# KENWOOD Service Bulletin

ASB-1061

**Subject:** TM-733A PL Tone Bleed Through **Date:** December 5, 2006

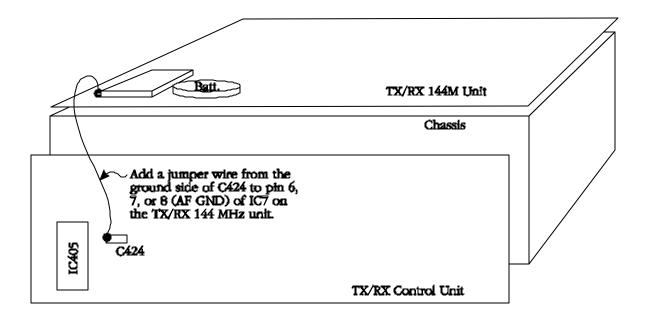
When transmitting a PL tone a "humming noise" might be heard coming from the internal speaker of the TM-733A. This is caused by a difference of potential between the tone generating circuit and the AF amplifier circuit.

This symptom is corrected by tying the ground connections in the AF amplifier and Tone generating circuits together.

- 7. Install the new screws and star washers.
- 8. Solder a jumper wire from the ground side of C424 and pin number 8 of IC7 as shown in the accompanying illustration.
- 9. Reverse steps 1 5 for reassembly.
